Grosvenor-Strathmore WMATA Garage Expansion, Mandatory Referral MR2018026

Completed: 7/5/2018

Request to replace the existing surface parking lot at the Grosvenor-Strathmore Metro Station by expanding the existing 6-story, 1,484-space structured garage by 414-spaces, and reconfiguring the Arts Walk and Kiss & Ride.

Review Basis: Mandatory Referral, MD Land Use Code § 20-301.

Figure 2: Mandatory Referral Proposal – First Phase of Redevelopment

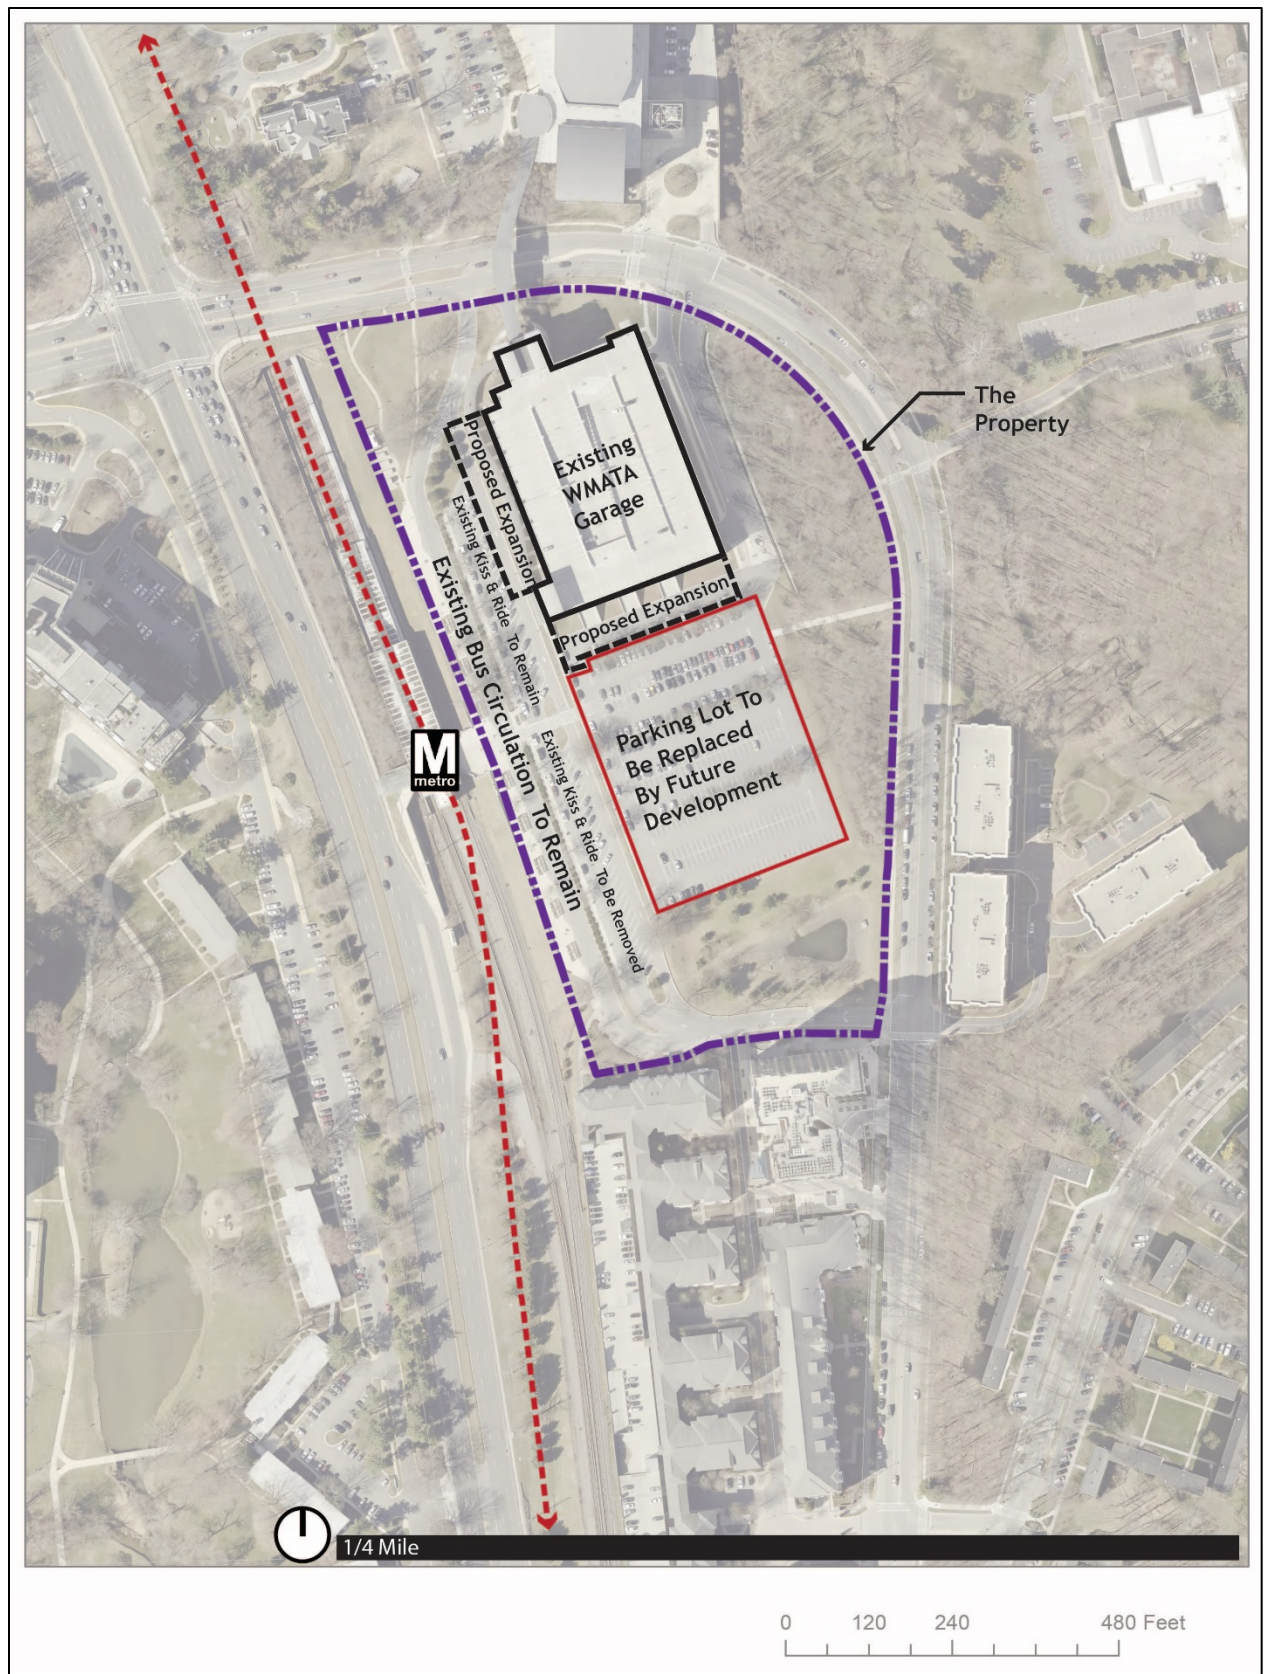
- *Neighborhood Green.* The Minor Master Plan proposes to "locate a dog park or other active recreation amenity for the community at the open space between the northern edge of the existing Metro garage and Tuckerman Lane" (Minor Master Plan, page 69). The application locates two large stormwater facilities (MBF-3 and MBF-4) in this area, as a result, the majority of the usable space will be reserved for stormwater management. Additional concept drawings shared with Staff show a potential dog park, sidewalks, and seating area on a third of the proposed neighborhood green; a bioretention area with a bridge across it to an embankment on the middle third of the area; and a fenced-off bioretention pond on the final third of the neighborhood green area. Staff requests further review of the design of the proposed neighborhood green and the proportion of space dedicated to stormwater management through future phases of the development to ensure that the entire development site meets the ten percent Public Open Space requirement. If the neighborhood green will be delivered in phases, the Applicant should ensure that the layout of the stormwater management areas will not hinder the access and usability of the space as recommended within the Master Plan. If not addressed at the Mandatory Referral phase, design and implementation of the neighborhood green will need to be addressed during subsequent regulatory reviews of the remainder of the site.

- *Arts Walk.* The Plan recommends "expand[ing] the existing Arts Walk into a wider, linear Arts Plaza that connects the Metro Station entrance to Strathmore Hall, with features such as public art on the ground or surrounding buildings that celebrates music, hardscape, and tree plantings for shade" (Minor Master Plan, page 34). Application documents lack details about the final configuration and redesign of the Arts Walk. Staff is concerned about the quality of the pedestrian experience walking through this space. The garage overhang and proximity to Kiss & Ride may create the feeling of walking through a tunnel or a parking garage, and less like walking through a linear Arts Plaza. Before issuance of any building permit, the Applicant will need to submit the Arts Walk design, so Staff can review the design for compliance with concepts presented to the Planning Board.

1. Provide a neighborhood green with a dog park and active recreation in the green space between the parking garage and Tuckerman Lane. If the Neighborhood Green will be delivered in phases, ensure that the layout of the stormwater management areas will not hinder the access and usability of the space as recommended within the *Grosvenor-Strathmore Metro Area Minor Master Plan* (Minor Master Plan).

2. Enhance the Arts Walk to create a linear arts plaza with lighting and design elements that provide a pedestrian friendly and well-lit space with public art. The design of the space should be inviting for people to walk at ground level from the Metro Station to the Music Center at Strathmore. Prior to issuance of any building permit, the Applicant should submit to Staff the finalized design elements of the Arts Walk consistent with initial concepts shared with Staff and the Planning Board, subject to Staff's approval.

Figure 5: Master Plan Recommendations

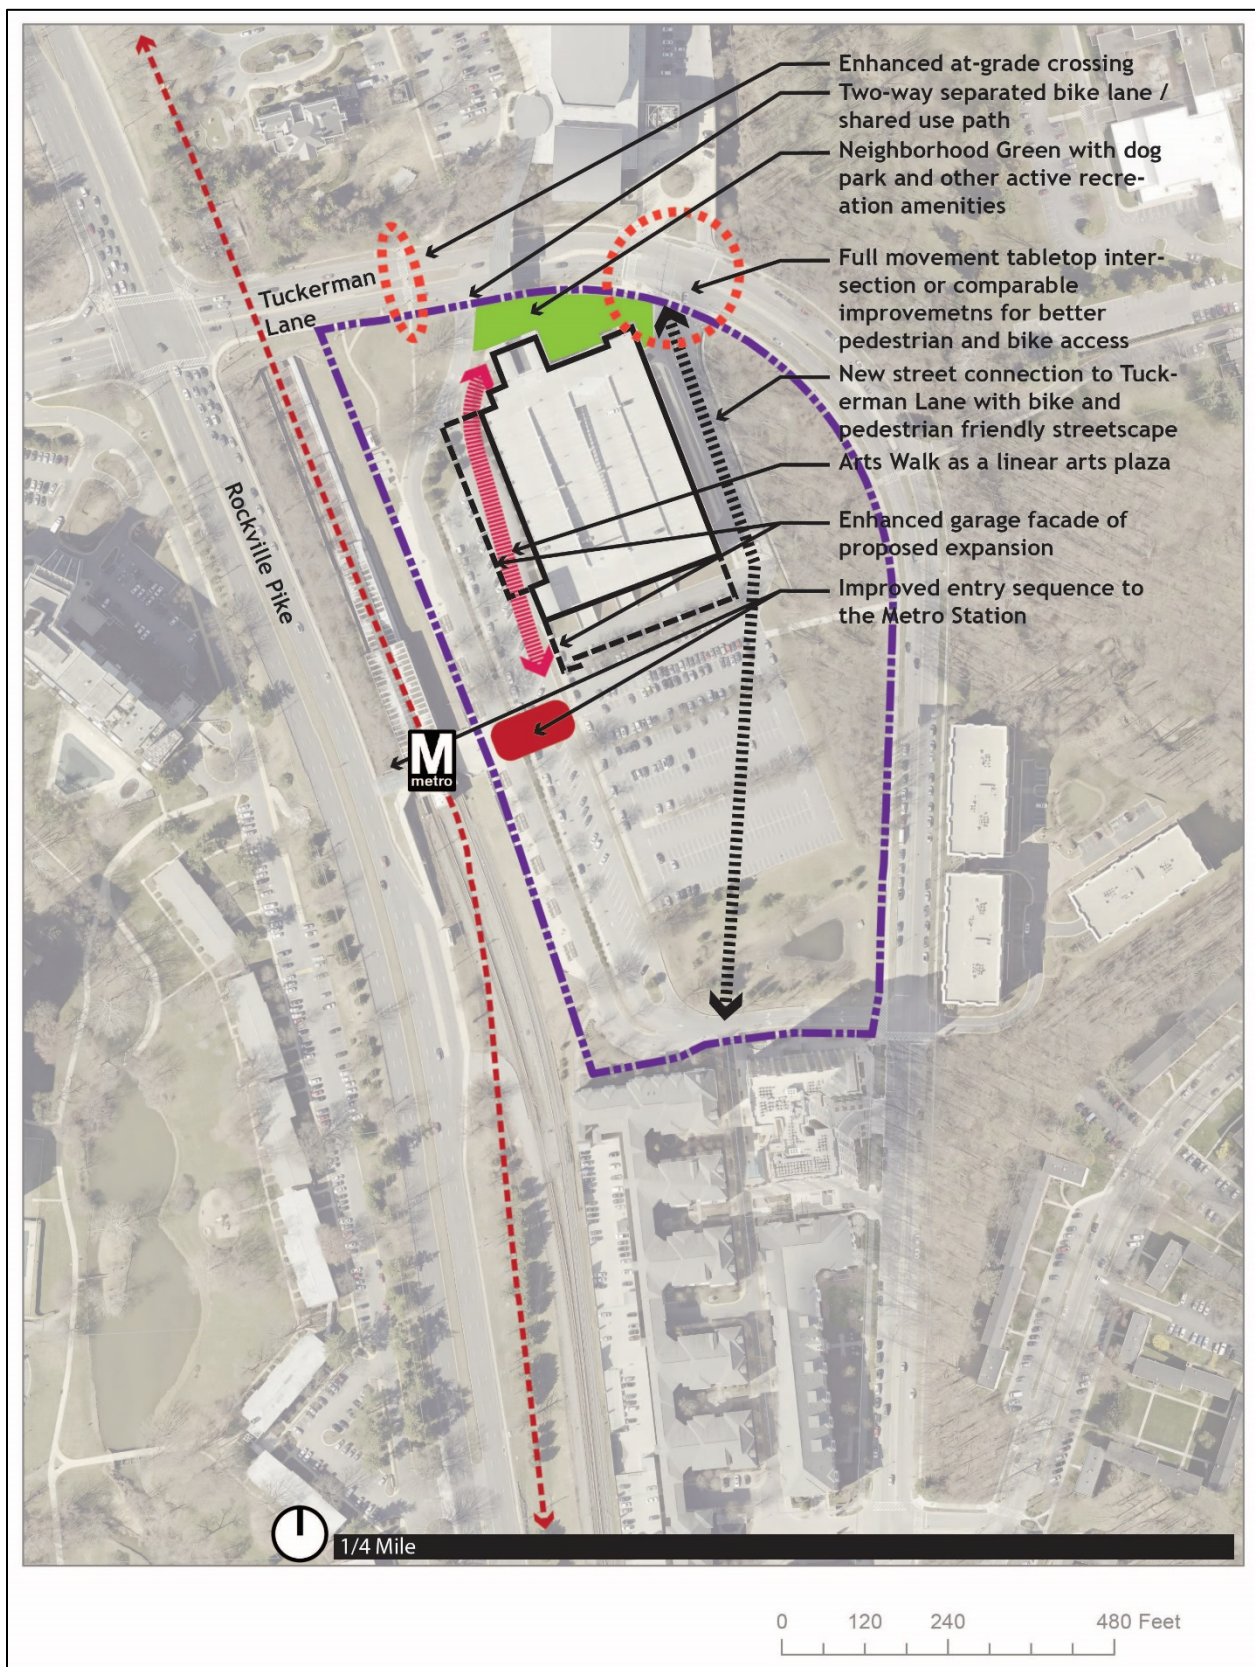
- *Improved intersection.* The intersection at Tuckerman Lane and the internal shared road to the parking garage is a key connection between the Metro and the Music Center at Strathmore. Currently, the wide curb cuts for the WMATA garage access road and high volume of vehicles entering and exiting Tuckerman Lane at this intersection act as a barrier to people traveling on foot or on bike on or across Tuckerman Lane. The Master Plan recommends that the intersection be a full-movement, raised intersection with special paving on Tuckerman Lane (Minor Master Plan, pages 50-51). The intent of the recommendation is to increase the visibility of pedestrians and bicyclists. The Applicant expressed concern that the significant volume of bus and other vehicular traffic could damage a raised intersection. If a raised intersection truly is not possible, Staff recommends that the Applicant meet the intent of the recommendation by installing comparable improvements including, but not limited to special pavement areas, wider crosswalks, improved signal timing for pedestrian crossing, and unique paint or markings to enhance bicyclist and pedestrian visibility. Improvements to the intersection will need to be addressed during subsequent regulatory reviews of the remainder of the site if they are not addressed during the Mandatory Referral.

- The Master Plan recommends enhancing the at-grade, mid-block crossing from the Metro Station to the ramp leading up to Strathmore Hall (page 50). Improvement of the crossing will need to be addressed during regulatory review of the remainder of the site if it is not addressed during the Mandatory Referral.

- *Metro entrance.* The Master Plan recommends improving the approaches to the Metro Station entrances with special paving, pedestrian friendly sidewalks and paths on both sides of the platforms (Minor Master Plan, page 71). Improvements to the station entrances will need to be addressed during subsequent regulatory reviews of the remainder of the site if not addressed during the Mandatory Referral.

3. In connection with future phases of development and subsequent regulatory approvals, provide a full-movement, raised intersection with special paving, or comparable intersection improvements at the intersection of Tuckerman Lane and the access road to the WMATA garage to improve pedestrian and bicycle accessibility to the site and to the Music Center at Strathmore across the street.

6. Enhance the at-grade mid-block crossing between the Metro Station and Strathmore Hall with pedestrian safety features, such as high visibility crosswalks.

11. Improve the entrance to the Metro Station with special paving, pedestrian friendly sidewalks, crosswalks and paths on both sides of the platforms.
12. Comply with the approval conditions in the related Final Forest Conservation Plan amendment.

**MANDATORY
REFERRAL
SITE
PLAN**

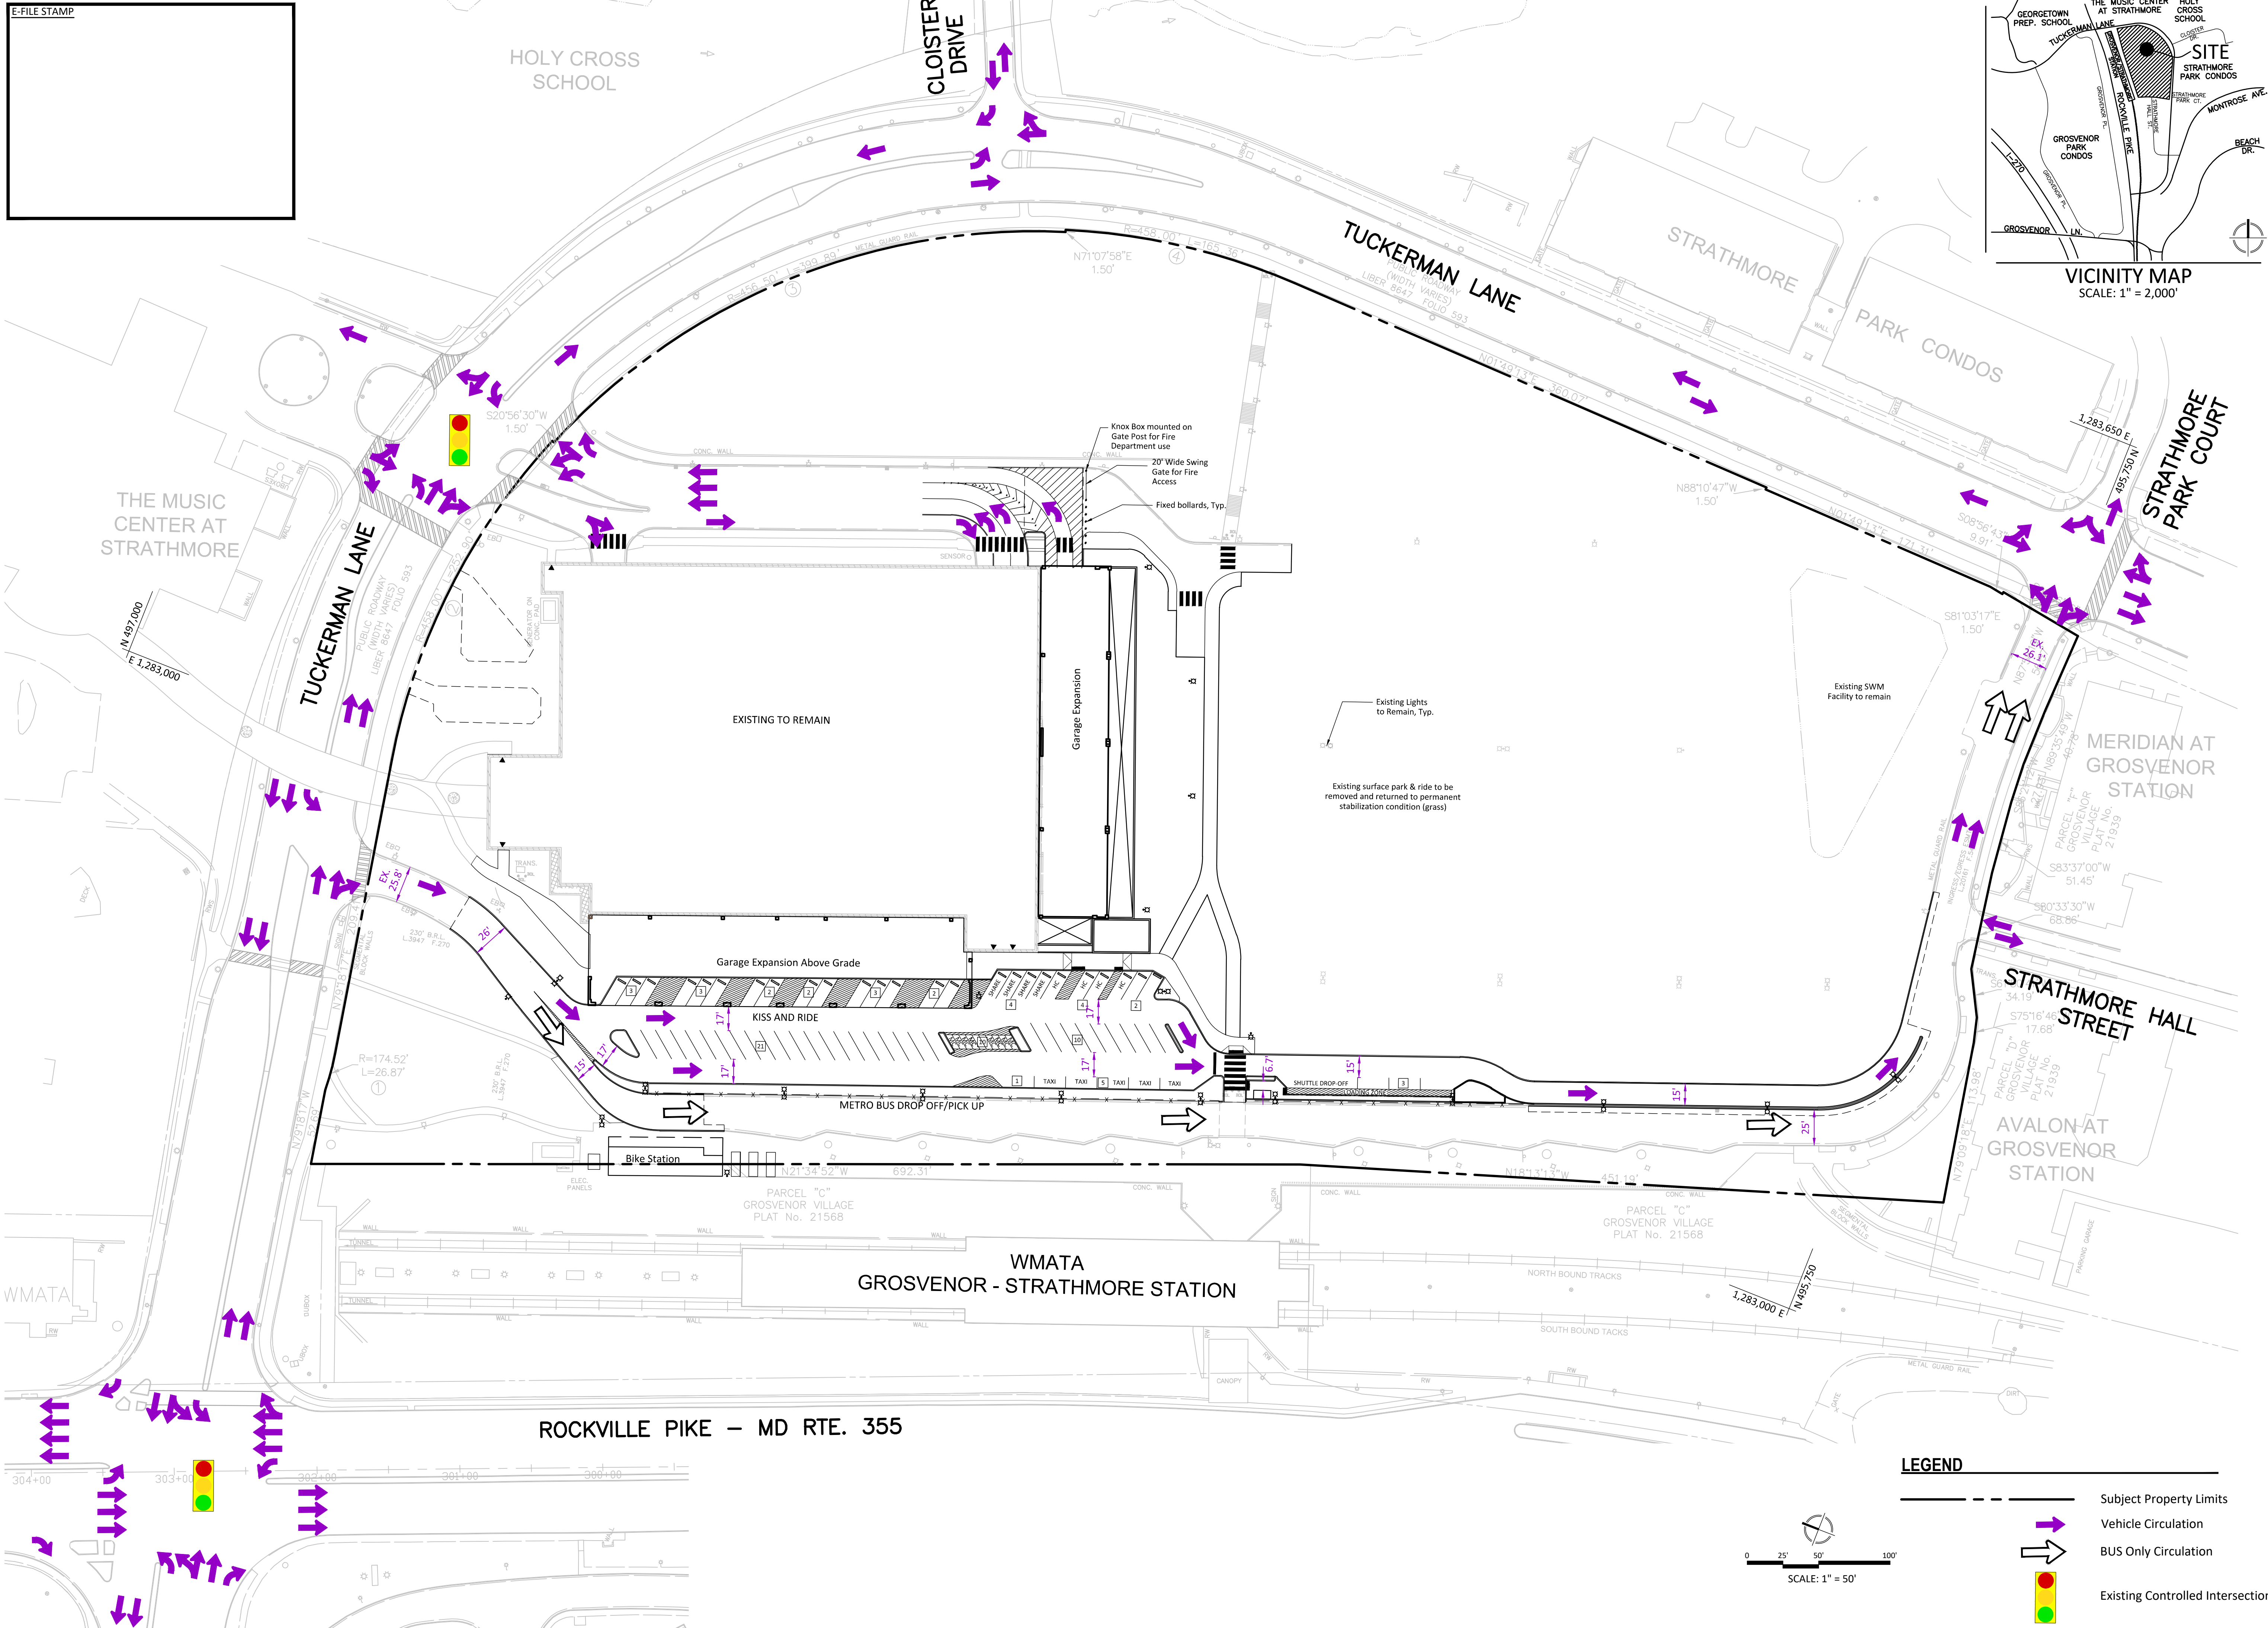
5. Reduce the turning radii and reconfigure the median at the exit from the proposed WMATA garage expansion to be more pedestrian and bike friendly while continuing to accommodate vehicle turns.

9. Replace the four-foot-high chain-link fence between the Kiss & Ride and bus drop-off areas with a more visually appealing alternative such as landscaping and/or ornamental fencing.
